PRODUCT DWG

Cinqplast 500ml Generic PET Trigger

SCALE	1:1, ISO
TOOL No.	NPD1106
SHEET	1 OF 1 SHEETS
DRG No.	PR4672
ISSUE	A B

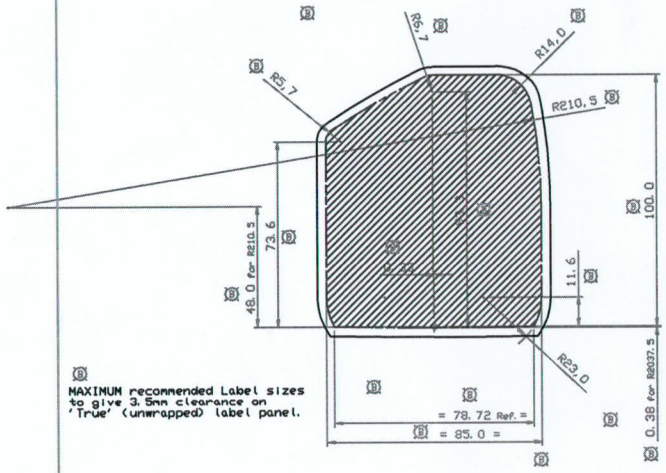
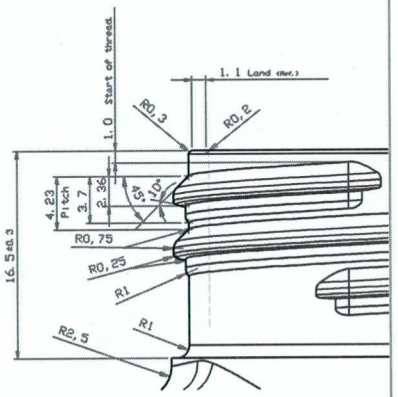
Concern about shingling made us increase label panel radius to reduce the curve - bottle width reduced.
R100 was R75
93.3 was 98.1
The change meant that the Label sizes changed as the 'True' unwrapped panel size changed.
LJK

MAXIMUM recommended Label sizes to give 3.5mm clearance on 'True' (unwrapped) label panel.
